FINAL DRAFT RESOURCE CONSERVATION AND RECOVERY FACILITY INVESTIGATION
CNC CHARLESTON SC
3/1/1991
KEMRON ENVIRONMENTAL SERVICES

Response to USEPA and SC DHEC Comments

**RCRA Facility Investigation Workplan (dated March 1991)
Charleston Naval Base
Charleston, South Carolina**

RESPONSES TO EPA
COMMENTS ON
RFI WORK PLAN (Dated March 1991)
FOR

Figure 2-1. Site location map.

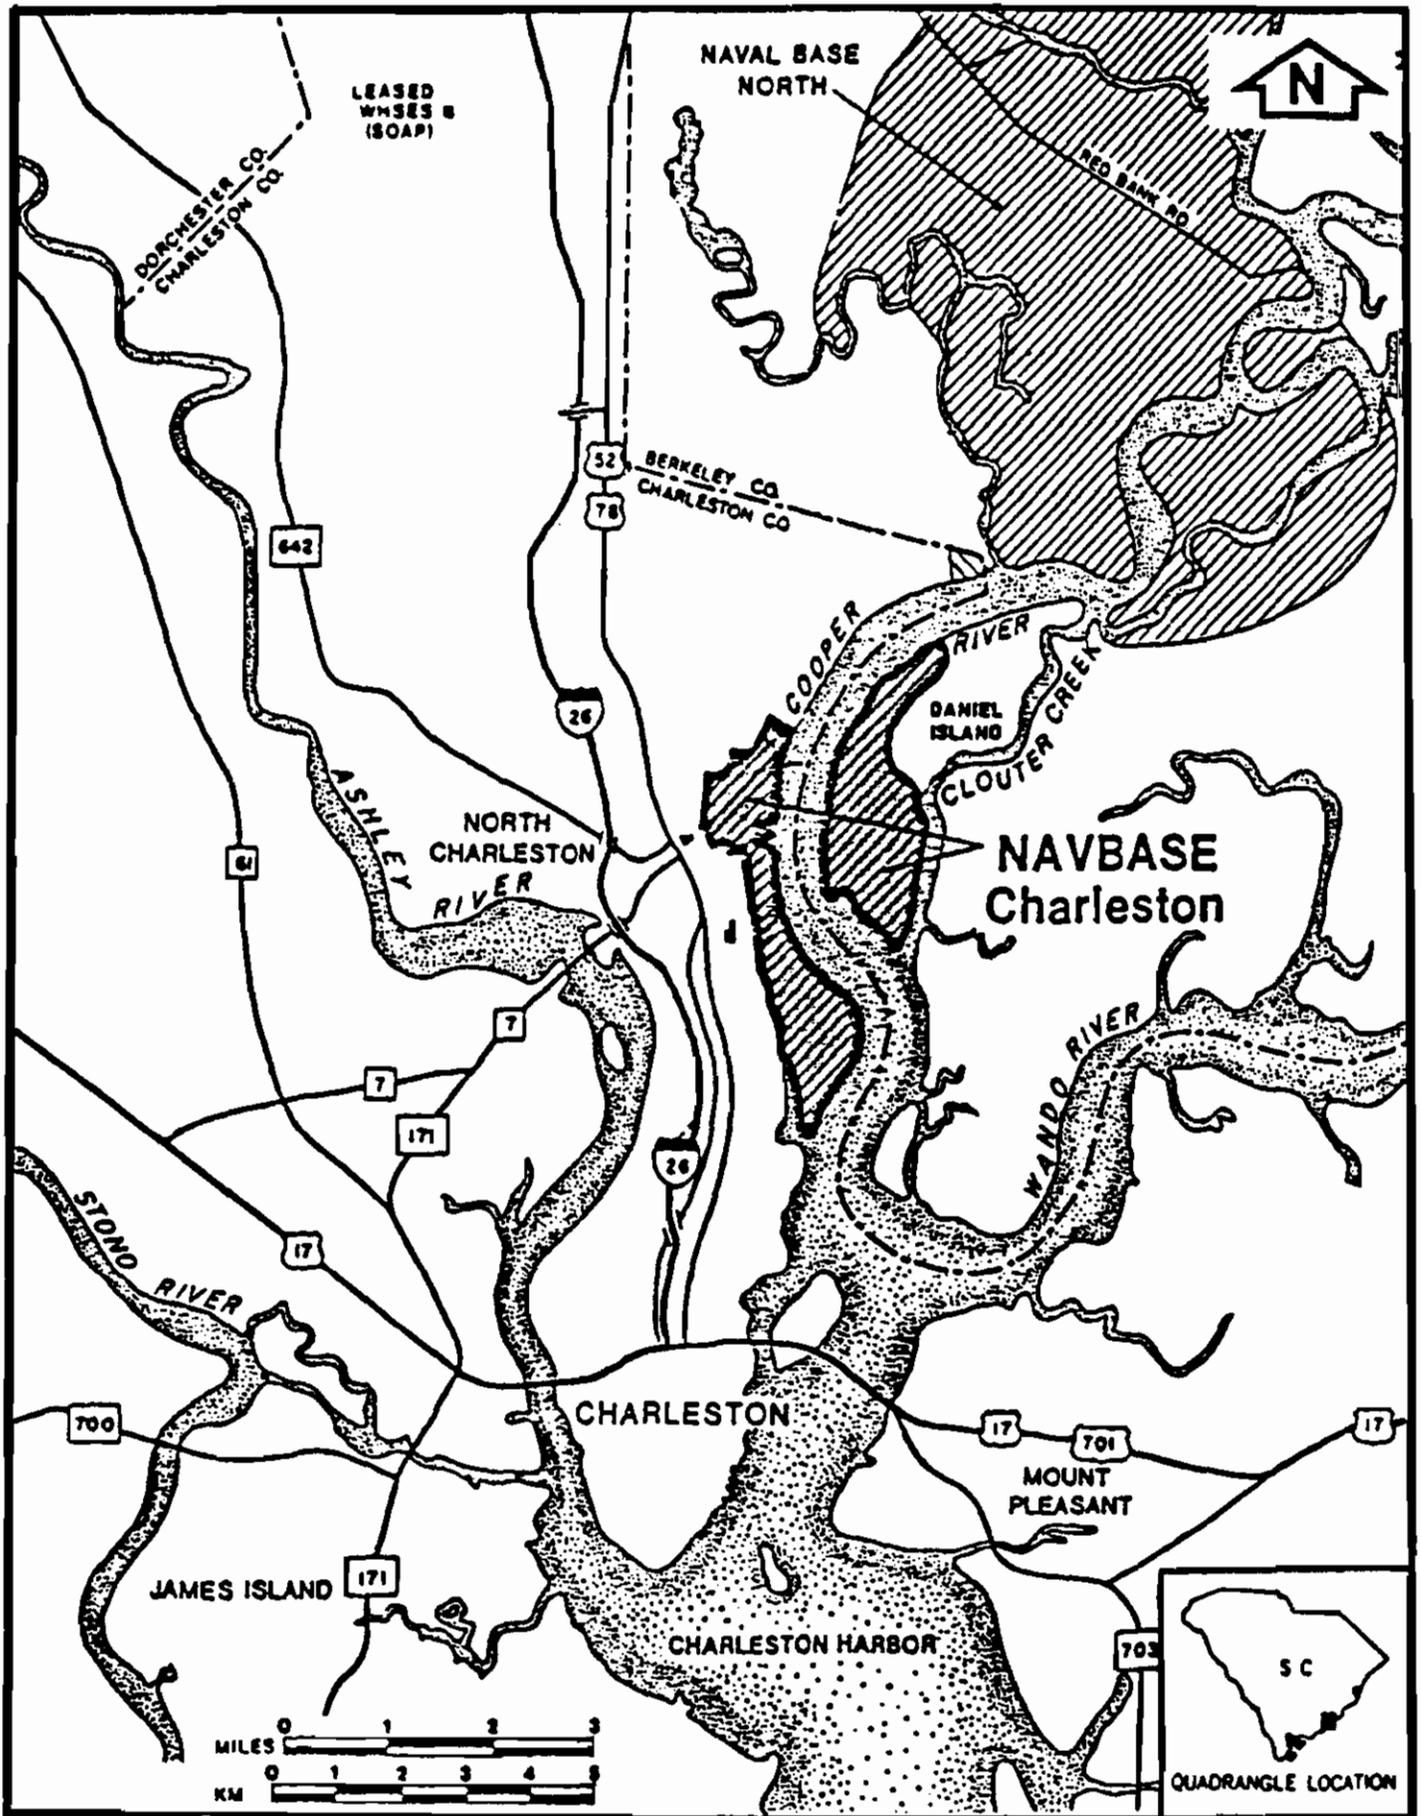
3. Figure 2-1

Response: This change to Figure 2-1 has been made.

Figure 3-4. Lead contaminated areas at SWMU #6.

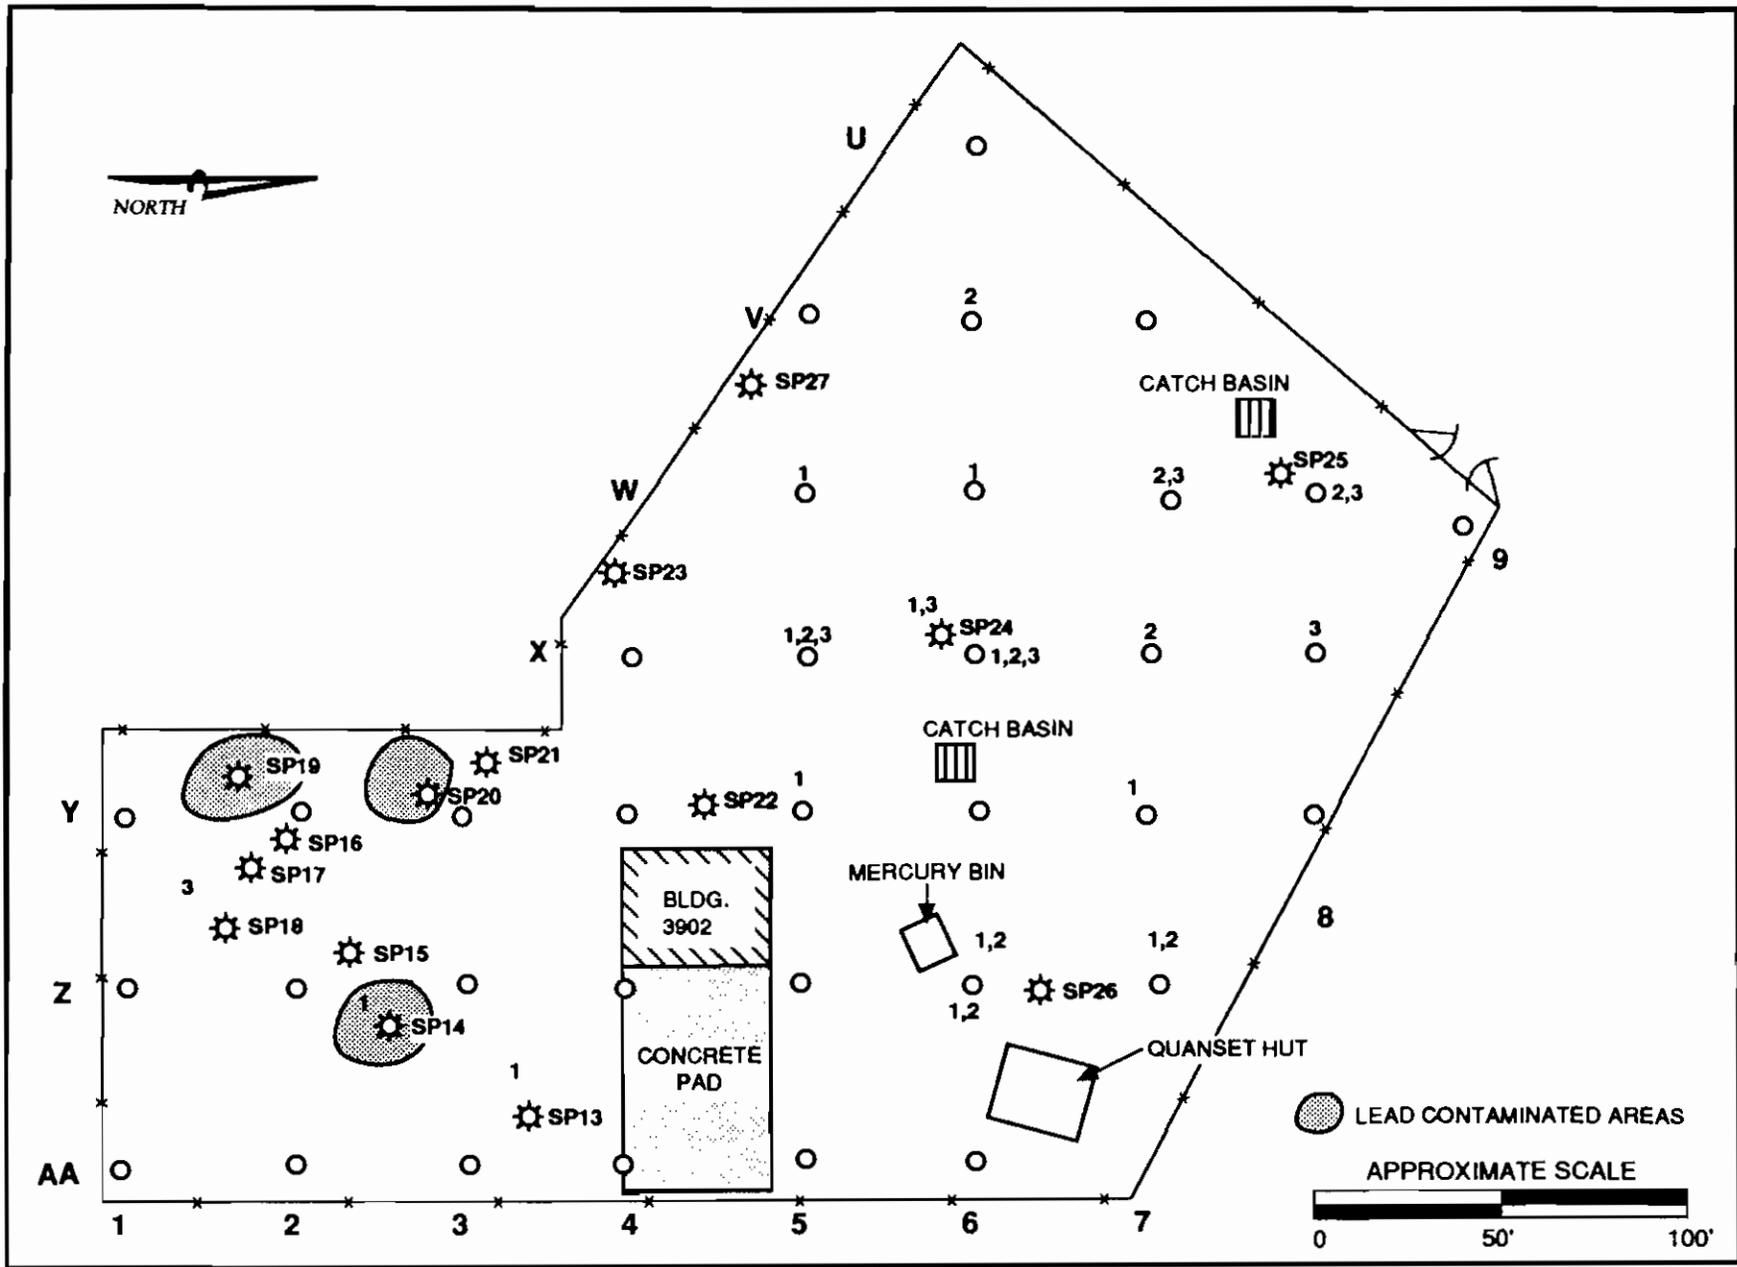
34. Figure 3-4

Provide a complete legend for the figure which identifies the symbols.

Response: The legend has been added.

Figure 3-5. Proposed sample grids at SWMU #7.

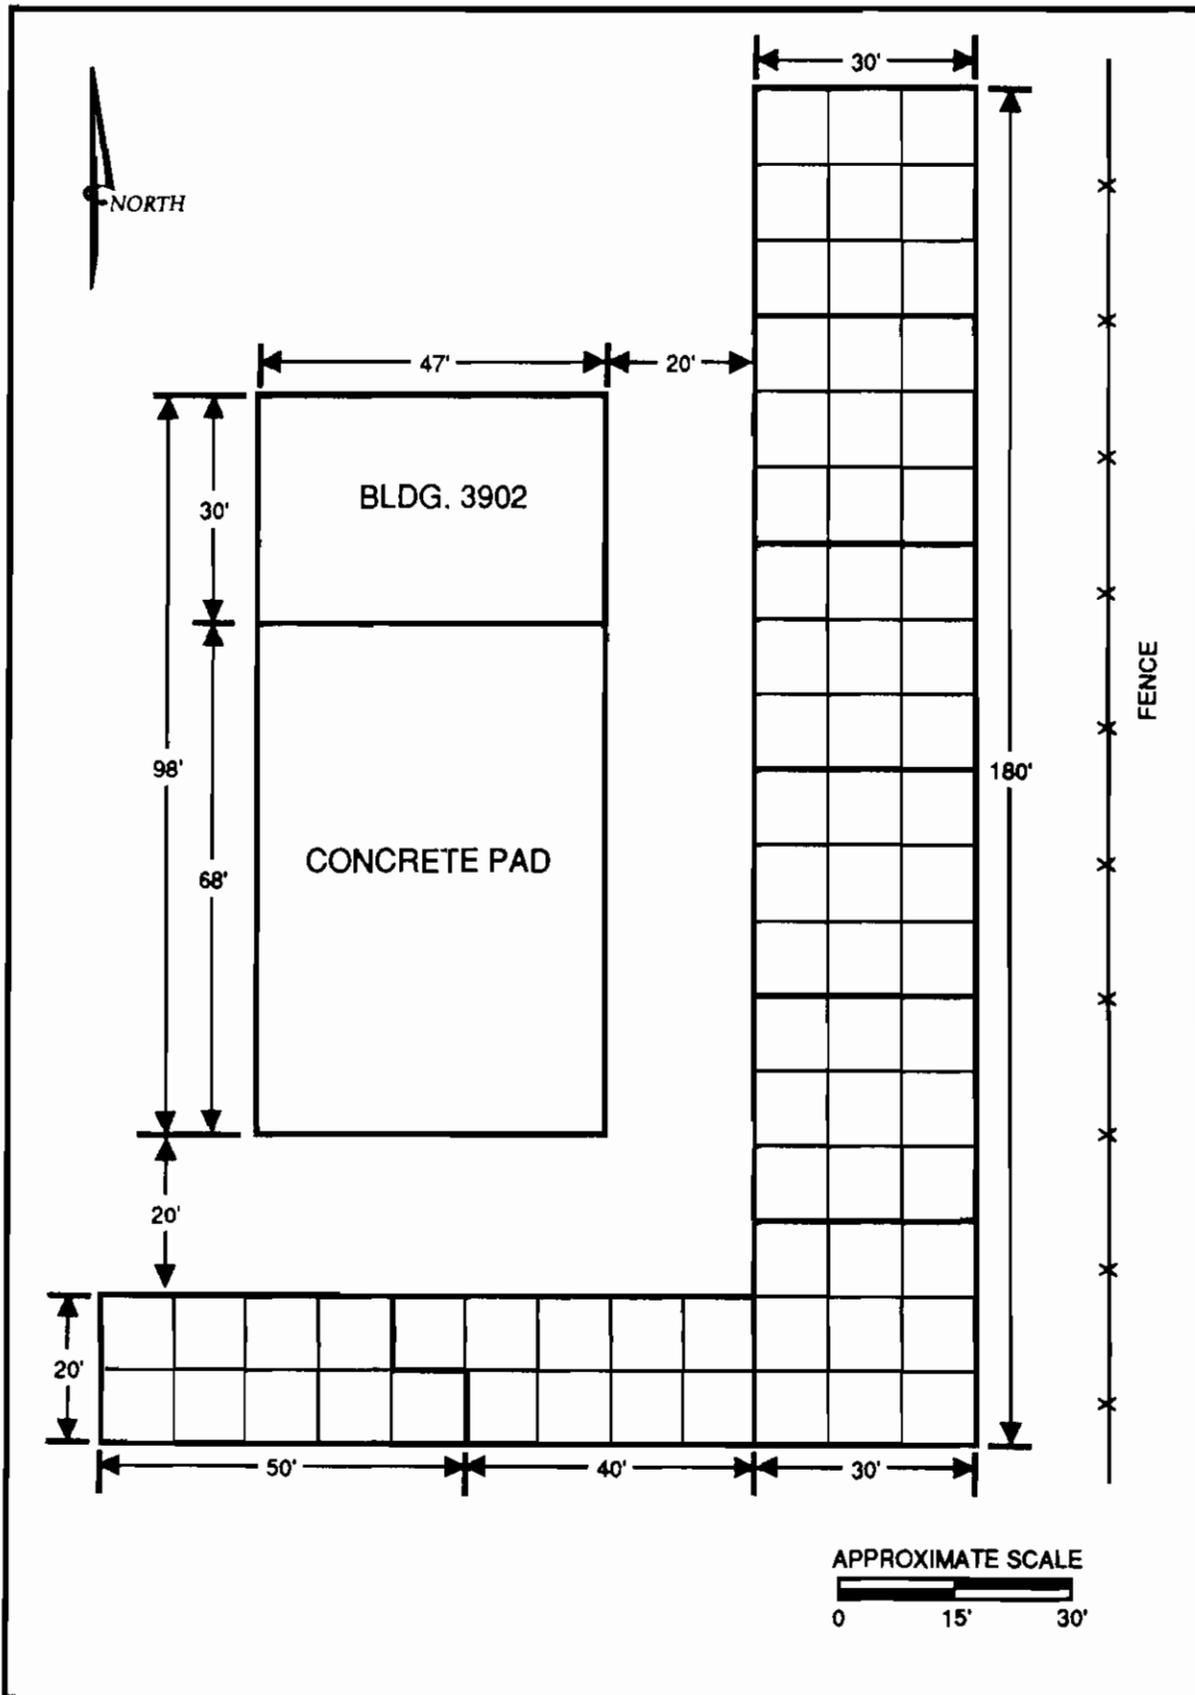
36. Figure 3-5

Why is the long axis of the concrete pad and bldg. 3902 in a different orientation on this figure as compared to Figure 3-4?

Response: This discrepancy has been rectified.

Figure 3-7. Proposed monitor well locations at SWMU #17.

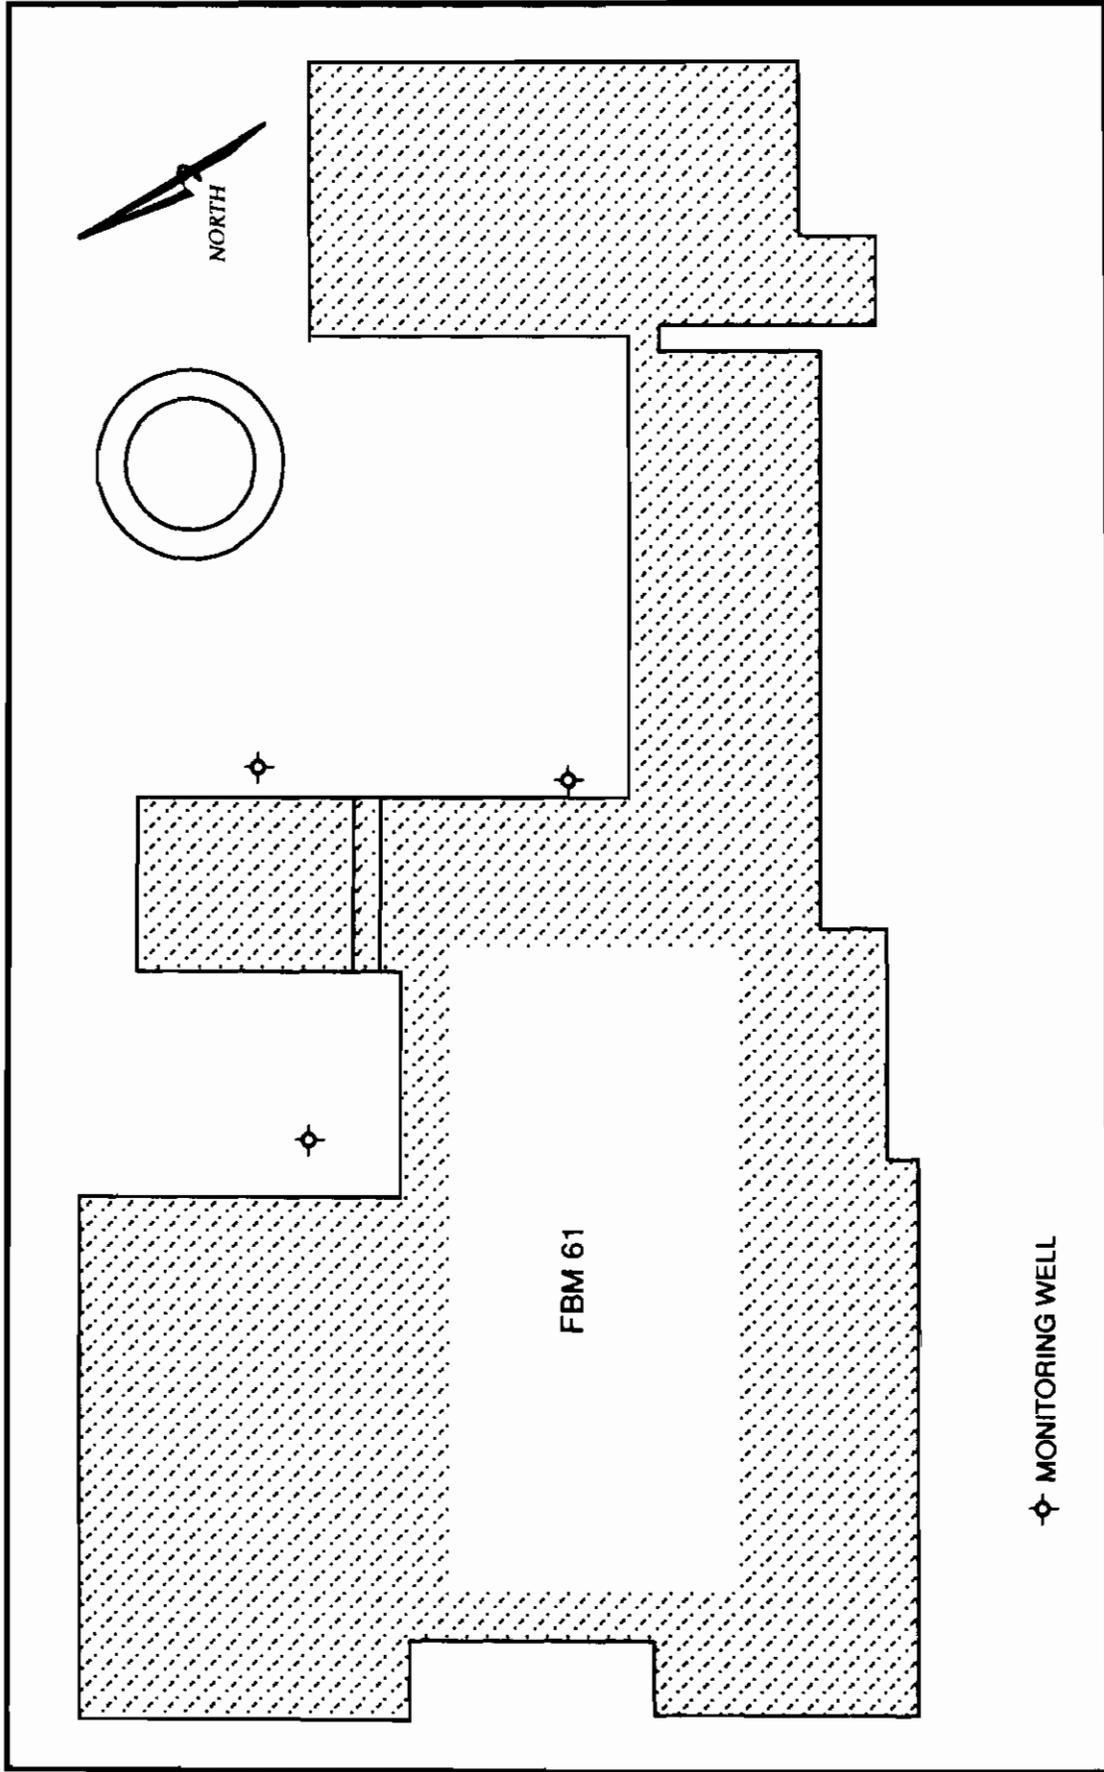
44. Figure 3-7

Response: The figure is now Figure 3-8. The prior studies are presented in Section 2.6.17. However data gaps still exist. Additional soil and groundwater sampling is planned in Section 3.9 for SWMU #17.

Figure 3-8. Proposed sample and monitor well locations at SWMU#25.

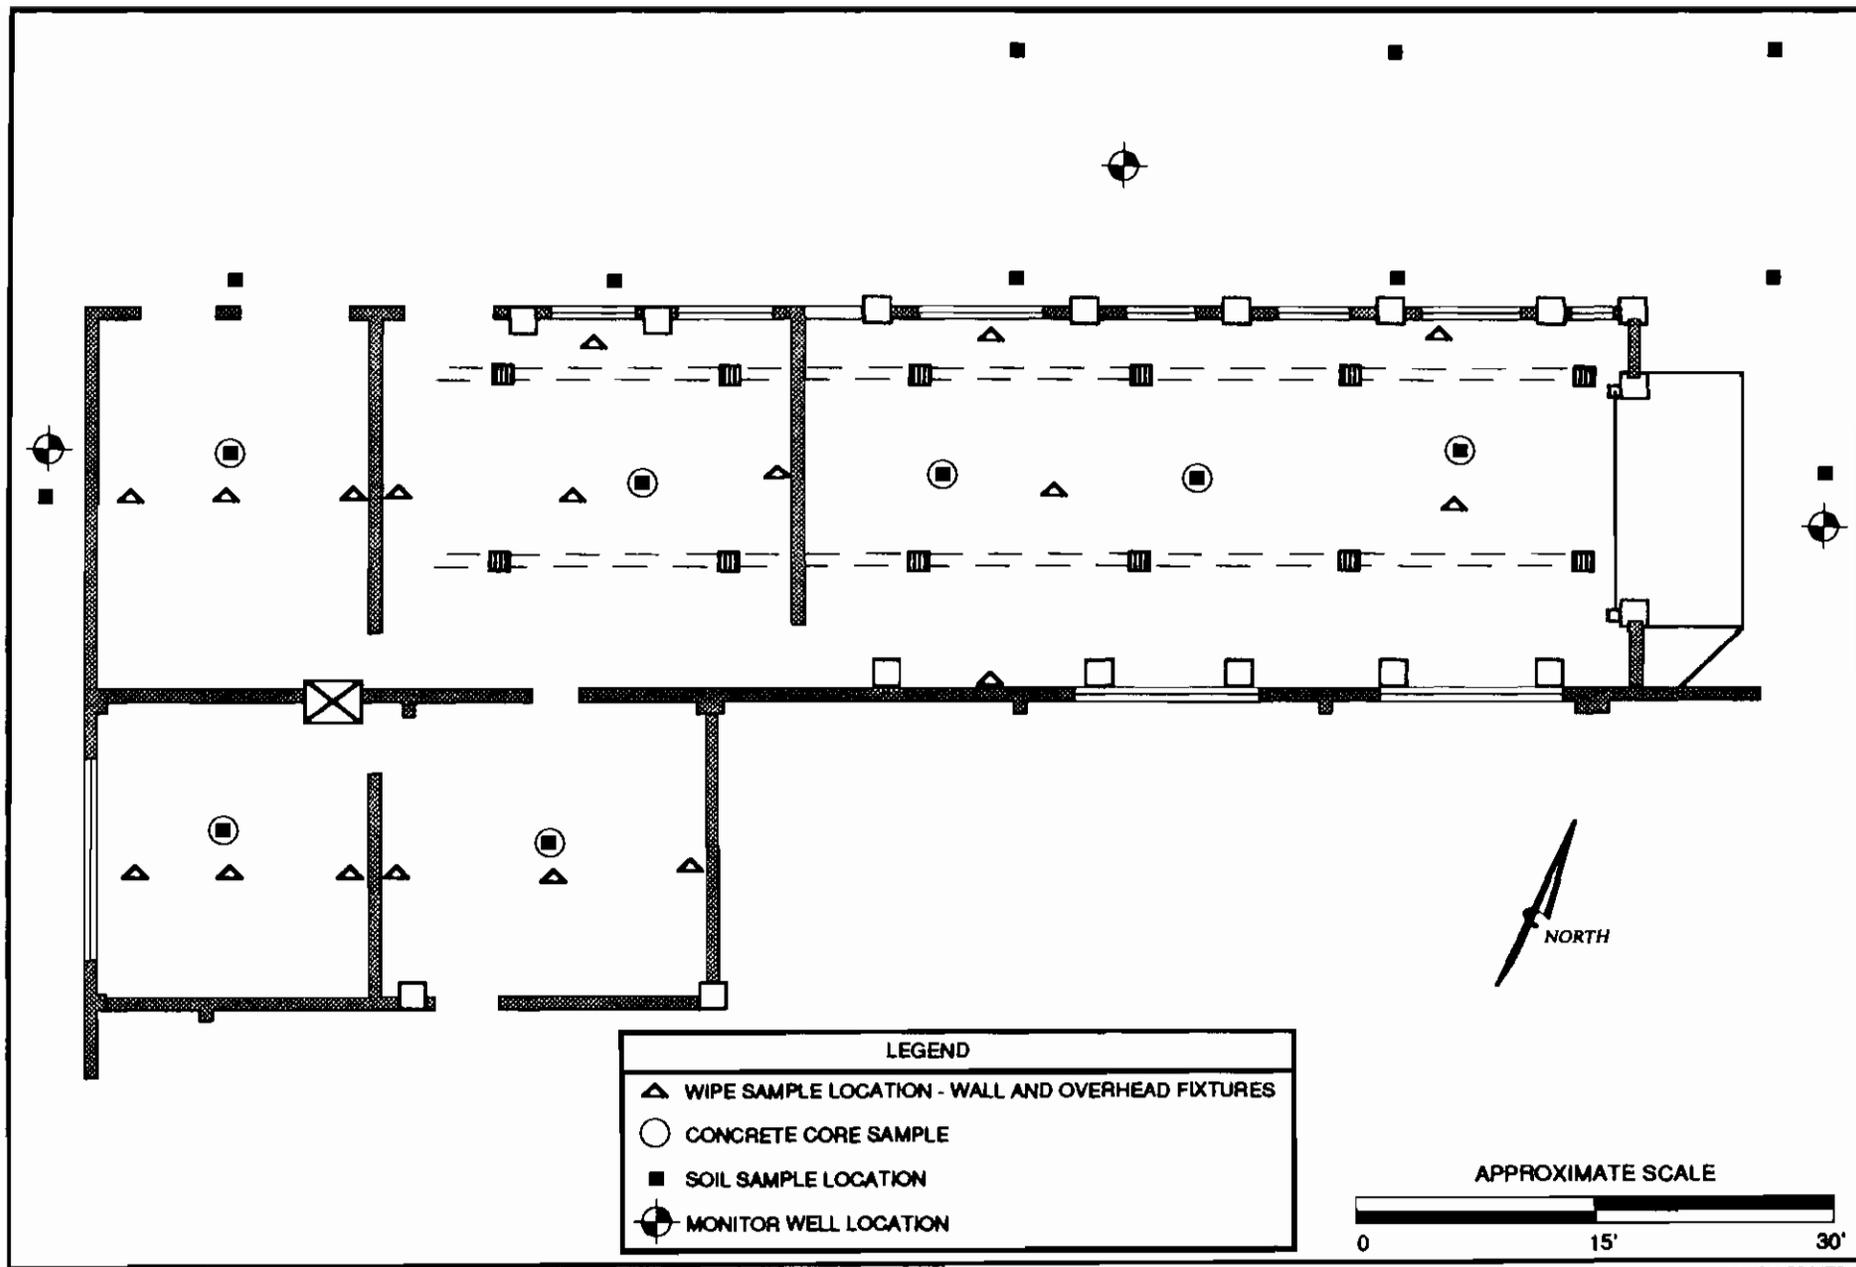
45. Figure 3-8

Response: The figure is now Figure 3-10. Additional data collected in 1991 is presented in Section 2.6.25. The floor drainage system will be investigated following demolition of the overlying structure.
